ERA Report on the Environmental Impact Assessment

PA 06705/17: Proposed lateral extension and amendments to the approved development in PA 00581/16 for the construction of underground car parking , mixed commercial uses including class uses 4A, 4B, 4C, 3C, 2C, 6A, and supermarket, at, The Quad Business Towers, Triq il-Merghat c/w, Triq l-Esportaturi, Birkirkara, Malta

Appendix – ERA Comments on update on Environmental Planning Statement

Appendix 1: Plan showing rainwater flow

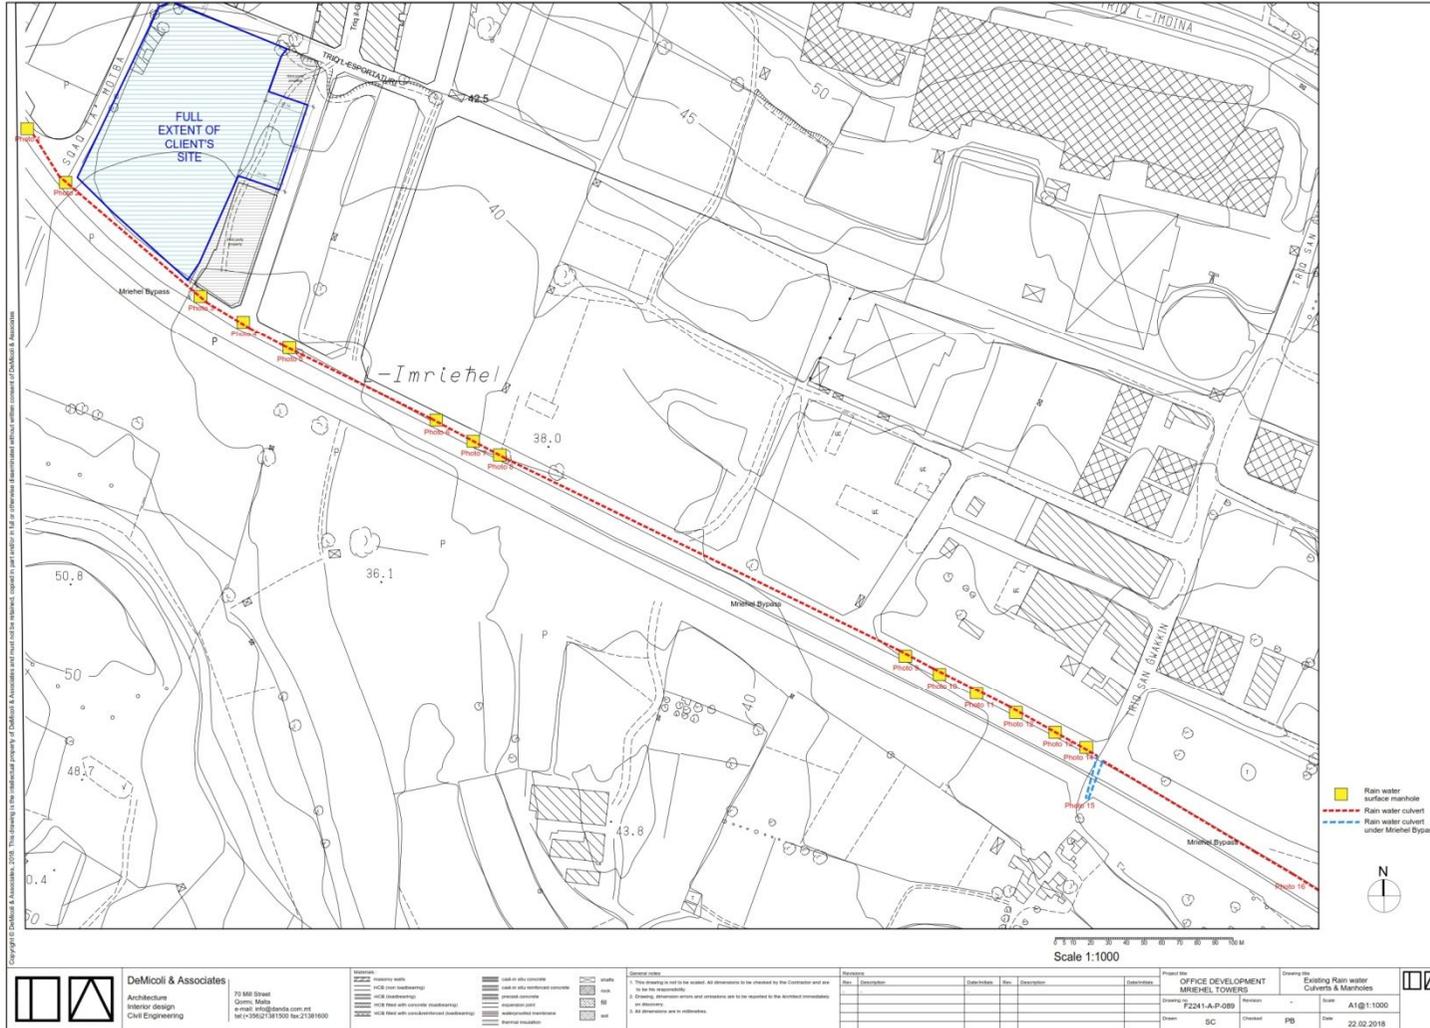
N o.	Page	Para.	Comment	Adi Associates' Response
General Comments				
1	30	2.28	The EPS Update indicates that “currently rain water runs into rain water grilles and eventually to this rain water trench, to eventually flow underneath Dawret I-Imriehel towards Wied is-Sewda”. This is to be clearly indicated on plan.	Plan provided in Appendix 1 .
2	49 – 65	/	Clearer versions of the baseline photographs and the photomontages are to be included in the EPS Update.	Baseline photographs and photomontages are included at the end as Appendix 2.
3	103	Table 5.5	Table 5.5 is incomplete in the hard copy of the document.	Noted. It printed as portrait instead of landscape. Table 5.5 included.
4	109	Table 6.1	Table 6.1 is incomplete in the hard copy of the document.	Noted. It printed as portrait instead of landscape. Table 6.1 included.
5	Appendix 1	/	Clearer versions of the baseline photographs and the photomontages are to be included in the EPS Update.	Baseline photographs and photomontages are included at the end as Appendix 2.
